SERVICE No.235 BULLETIN

Piper Aircraft Corporation
Lock Haven, Pennsylvania, U.S.A.

September 16, 1966 M

SUBJECT: Standardization of Never-To-Exceed Airspeed Limit

**PLACARD
PART NUMBER SK-1835**

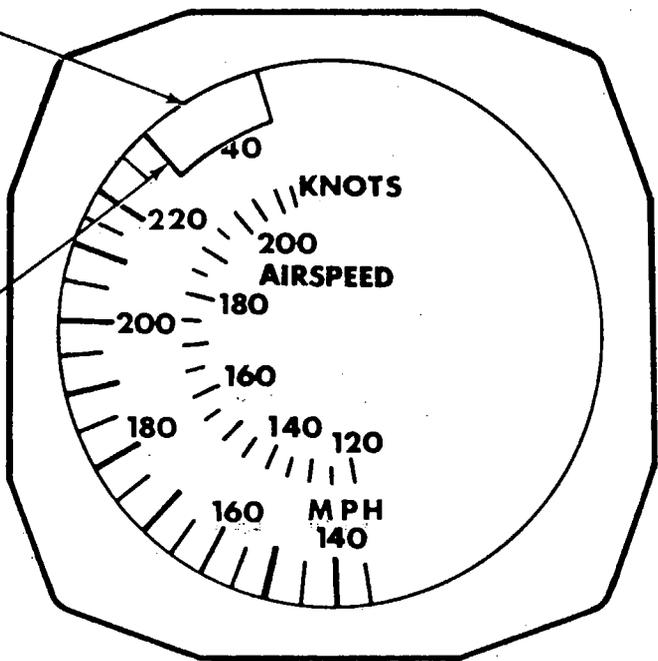
The installation of various optional equipment and S.T.C. approvals in the above referenced basic aircraft has made it desirable to standardize the never-to-exceed airspeed limit. The new never-to-exceed airspeed limit is 230 MPH.

Information concerning the installation of the airspeed placard is contained on the sketch on the reverse side of this bulletin.

**LOCATE THIS EDGE
OF PLACARD AT
230 MPH**
